Subject: Request for Proposal 2 - Changes to Backfill at Interior Retaining Walls

Project Name: Camden Rockport Middle School

Potential Change Order #007

Request for Proposal No. 002

OAK POINT ASSOCIATES
 SB505

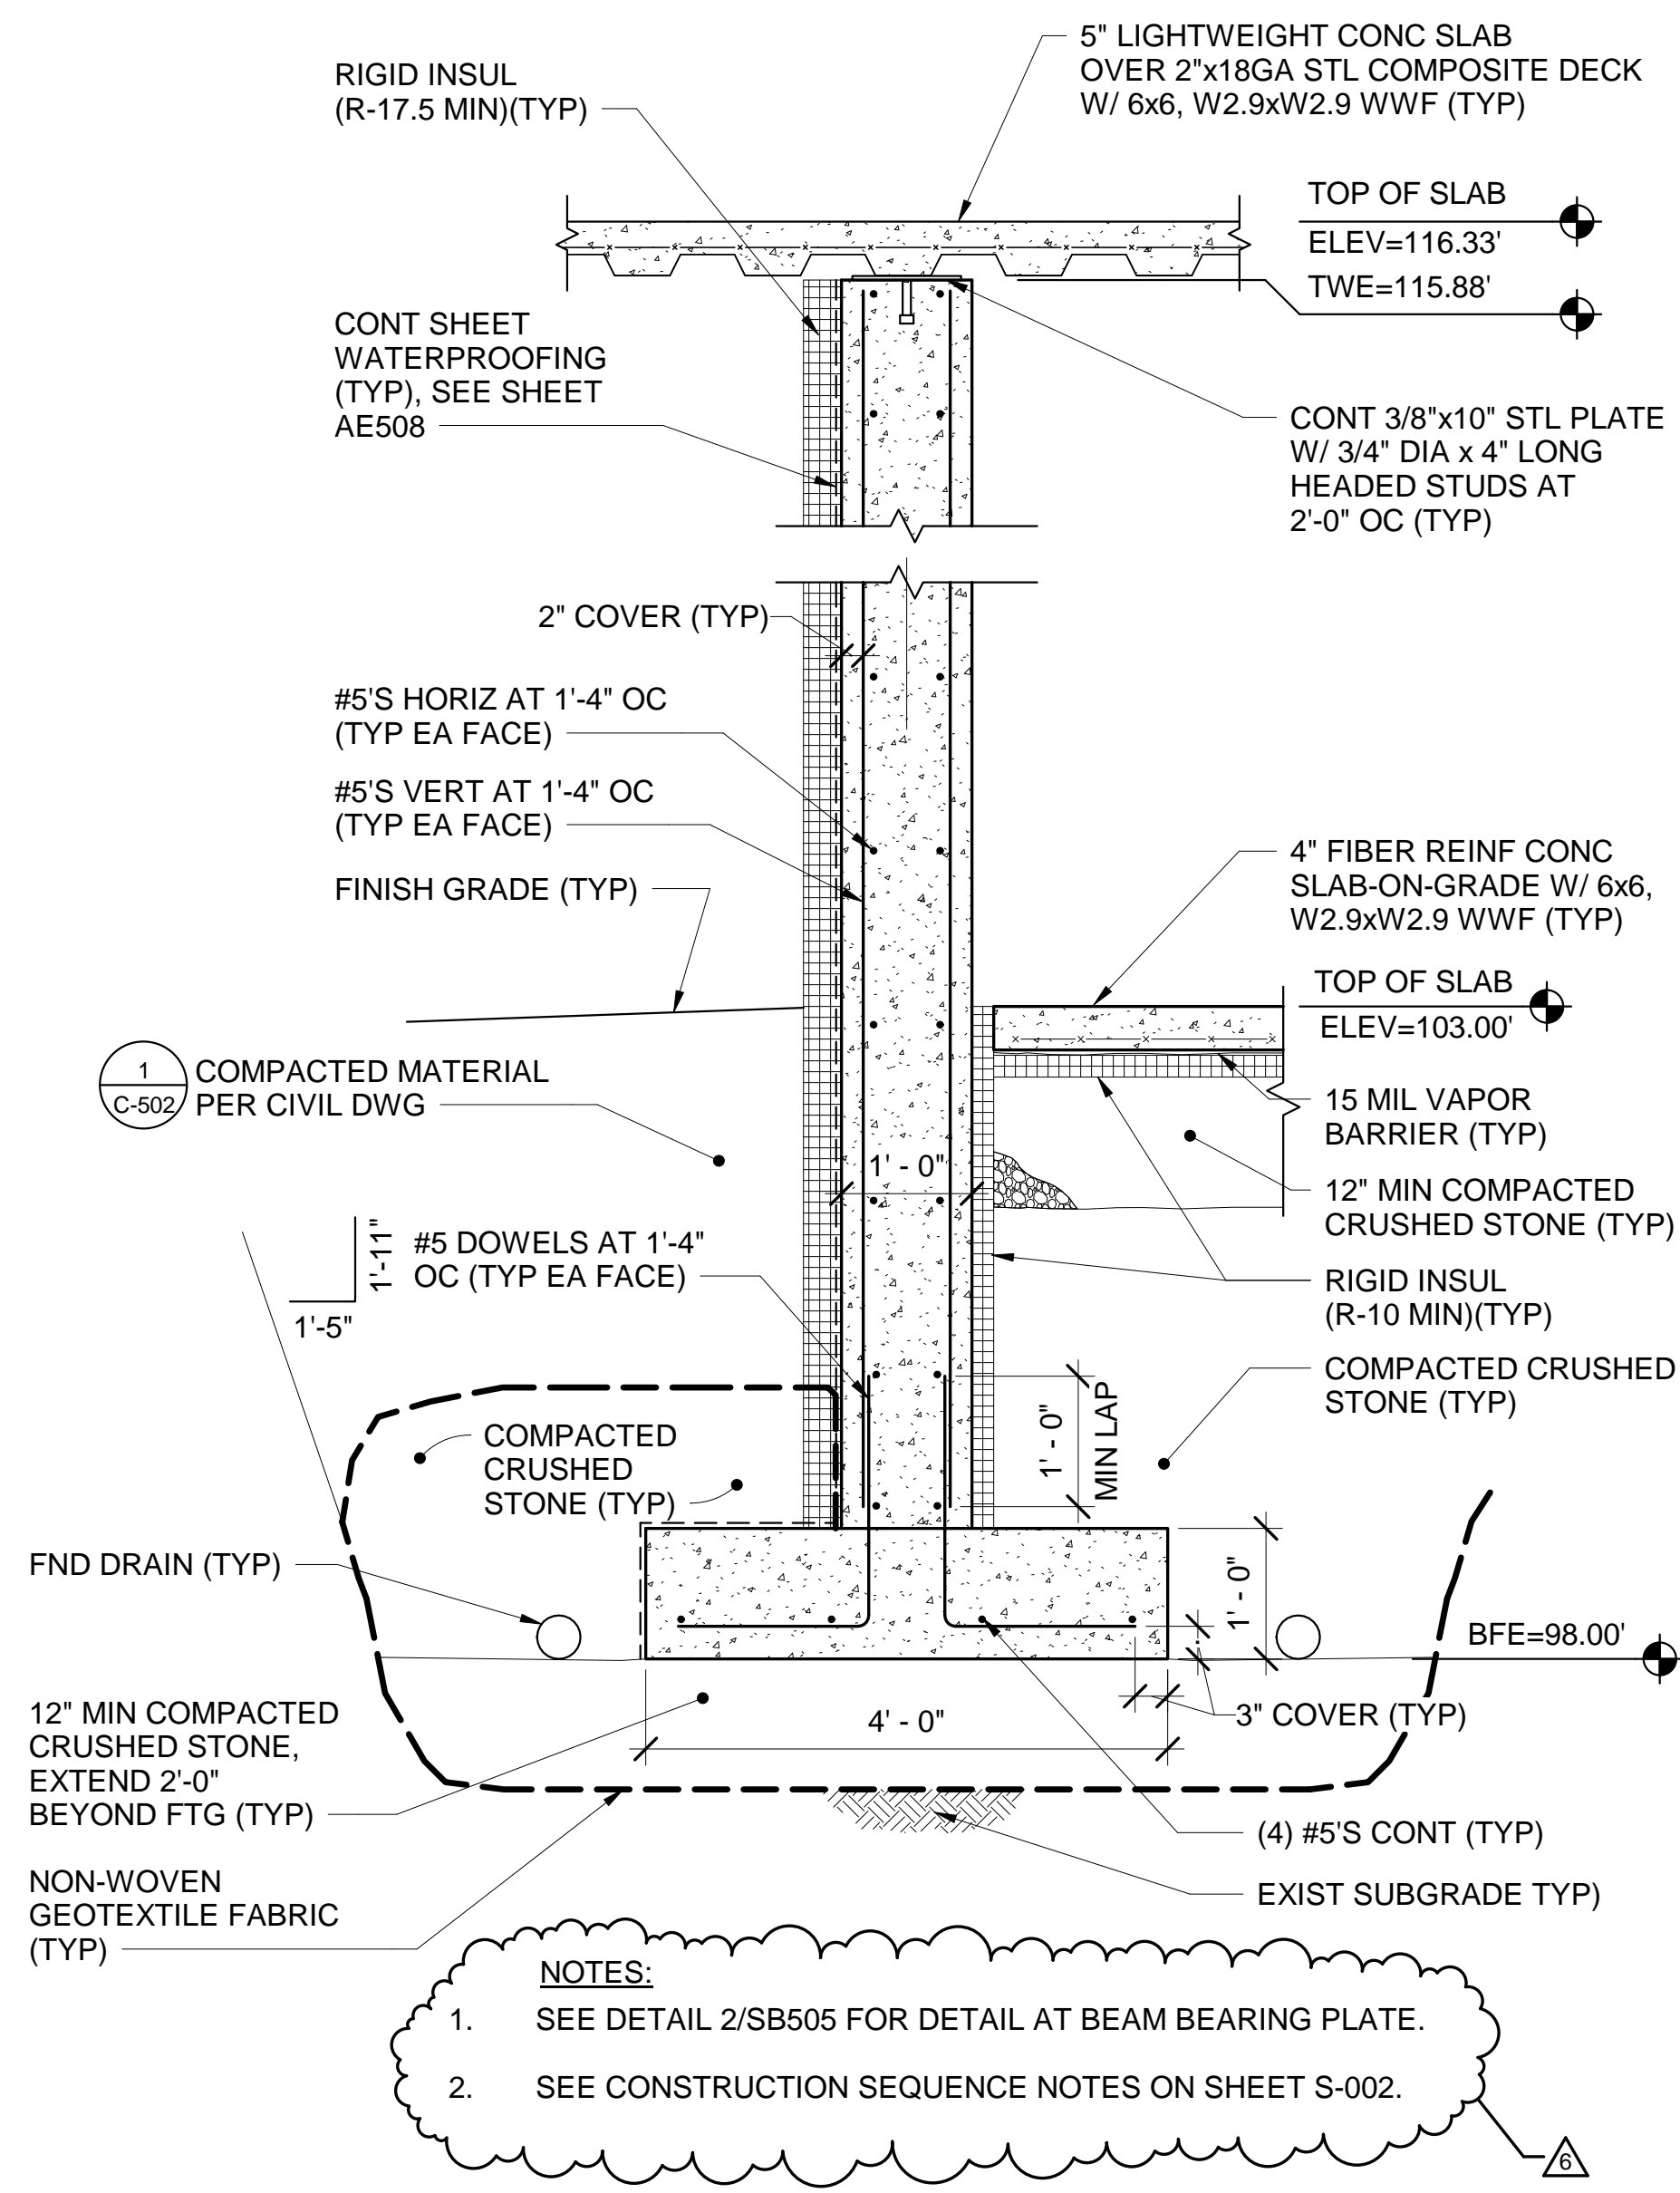
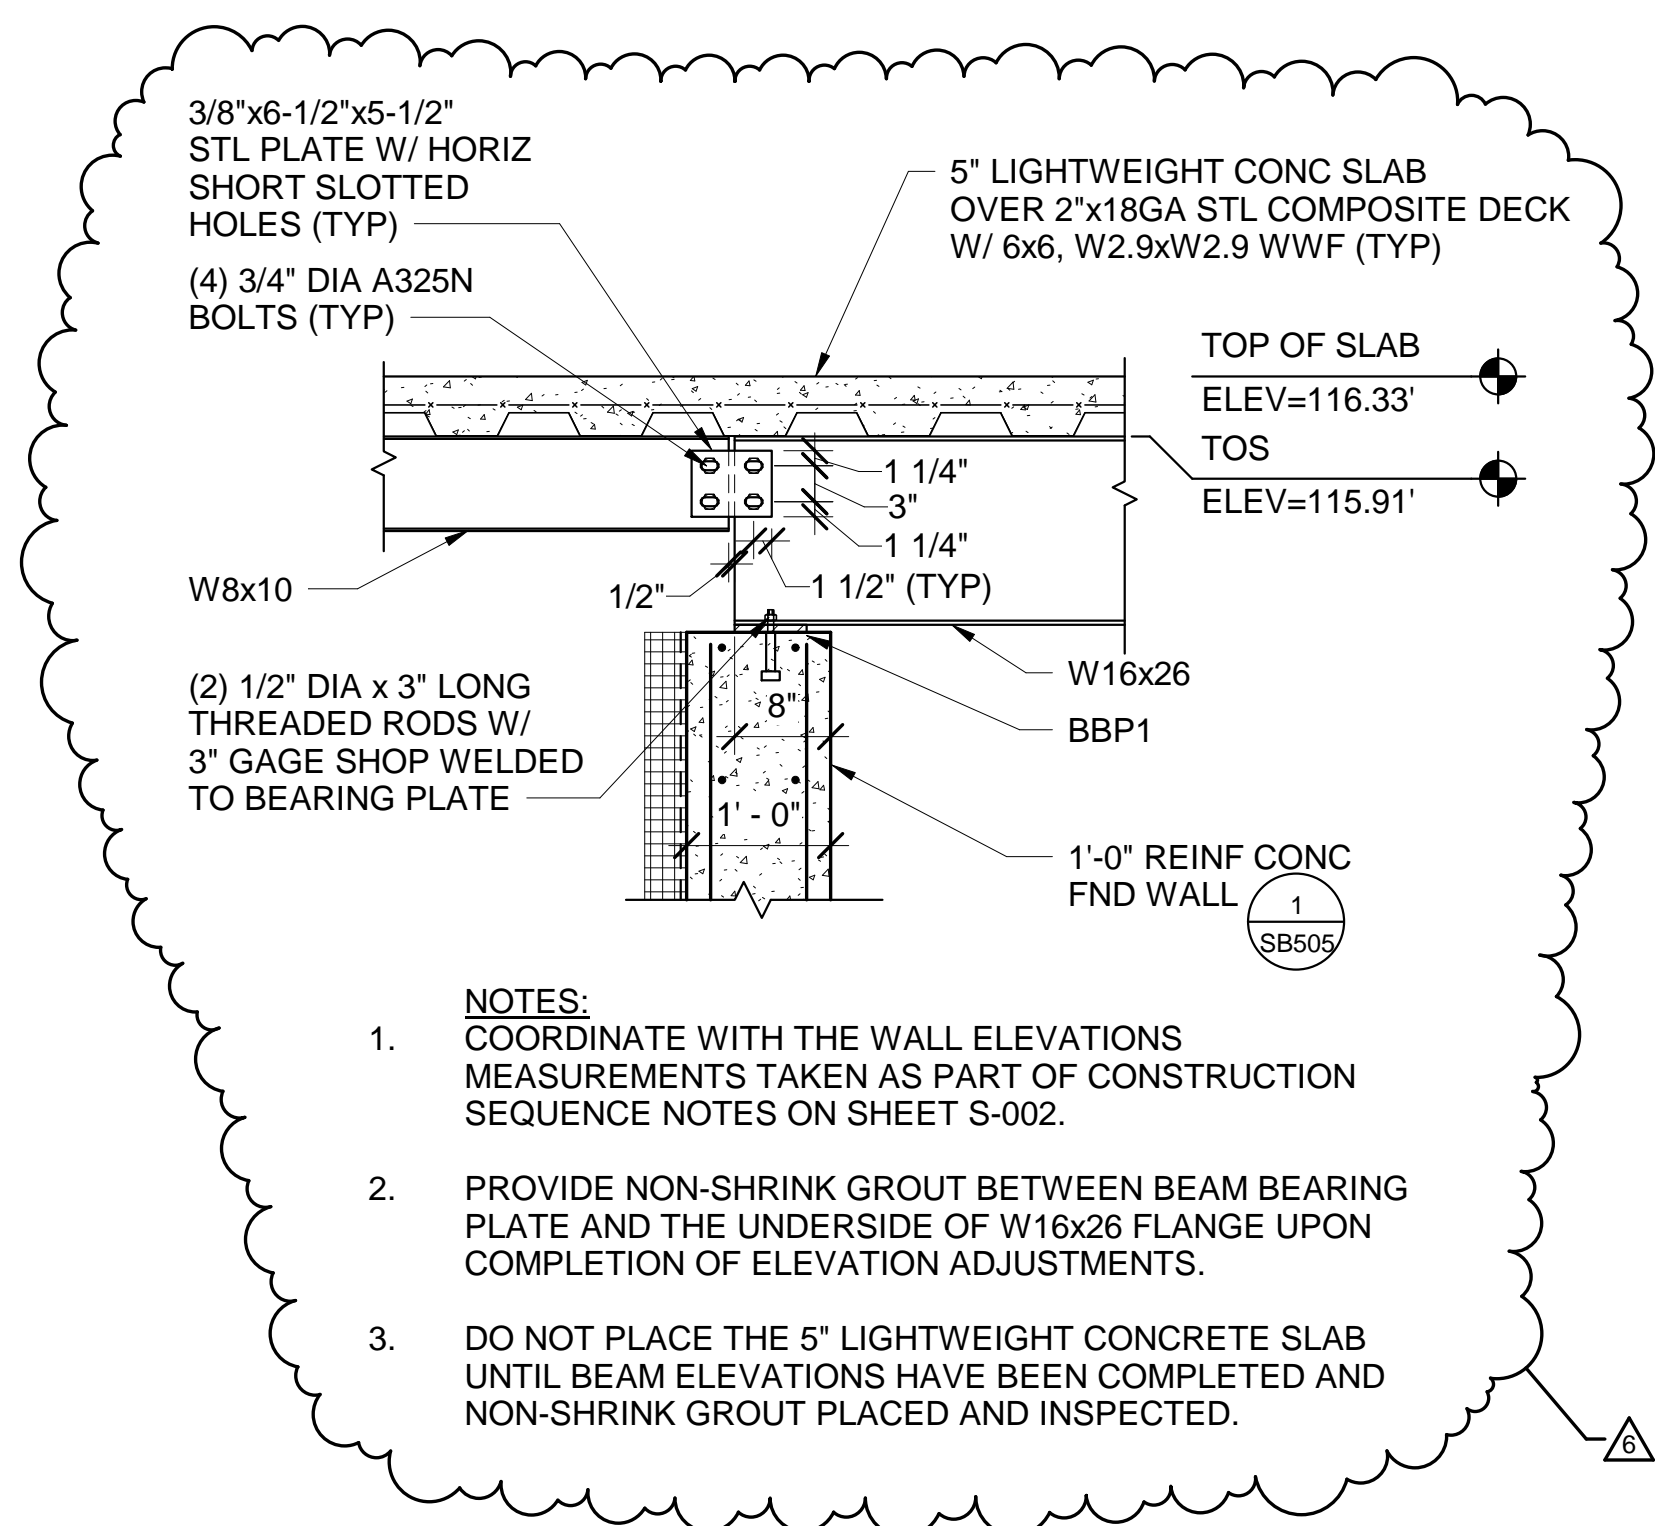
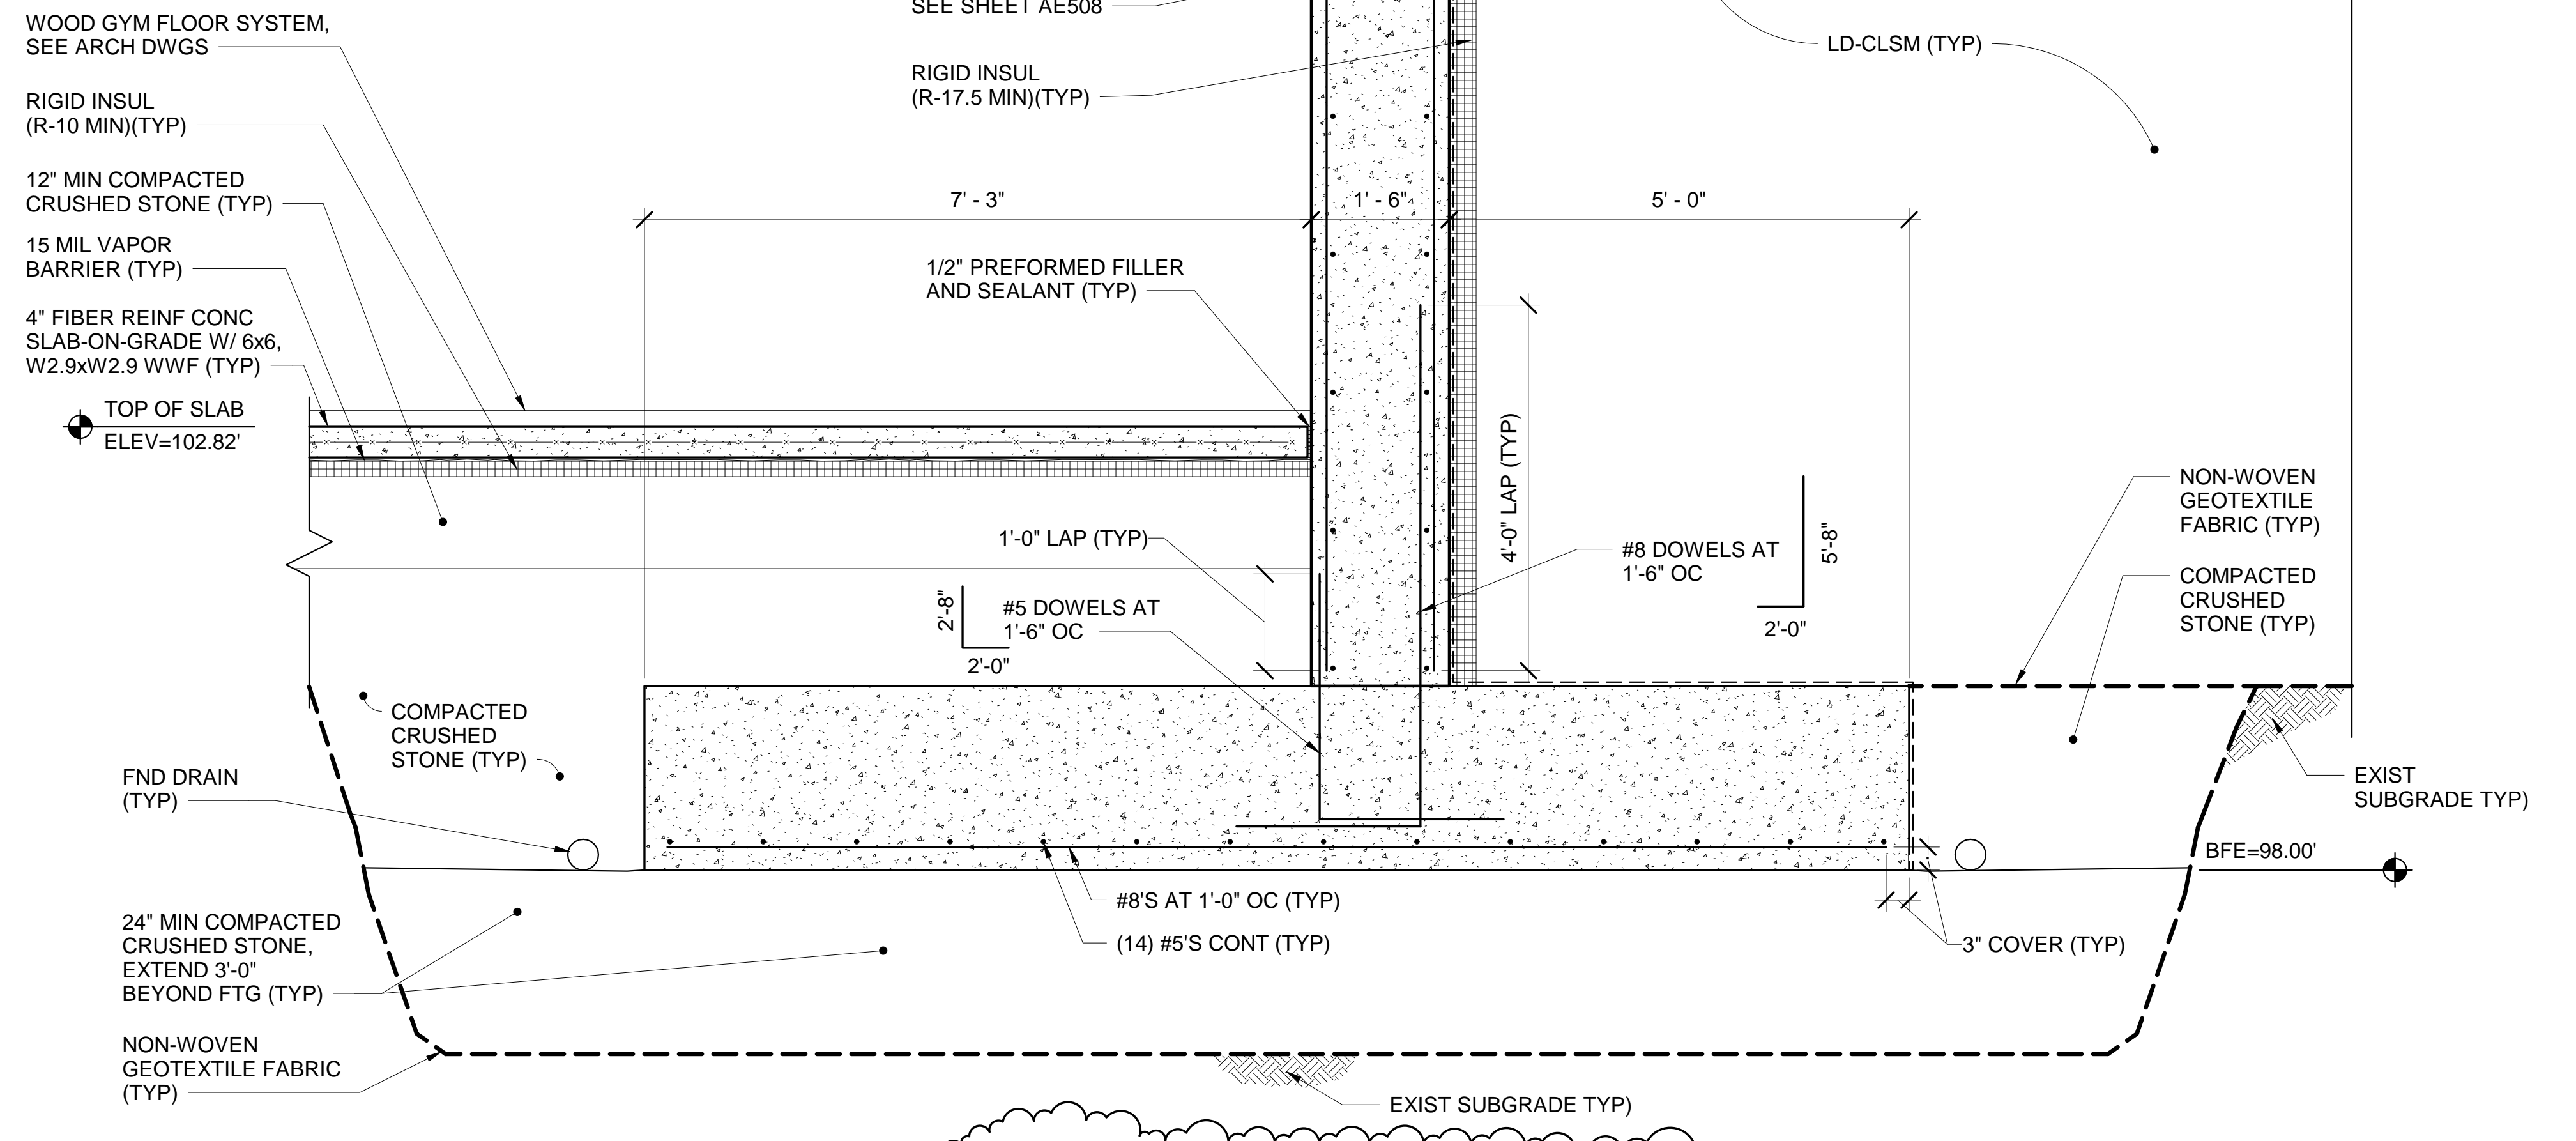
Gym Wall: There is no change to footing and wall forming square footage so costs remain the same.
Reducing the width of the footing will require cutting the reinforcing steel that has been supplied.

3. Revise reinforced concrete retaining wall indicated in detail 1/SB504.
4. Refer to attached drawings SB102 (**Revised 08-22-18**), SB503, SB503, SB504 and SB505 for modifications to foundation plans and details.
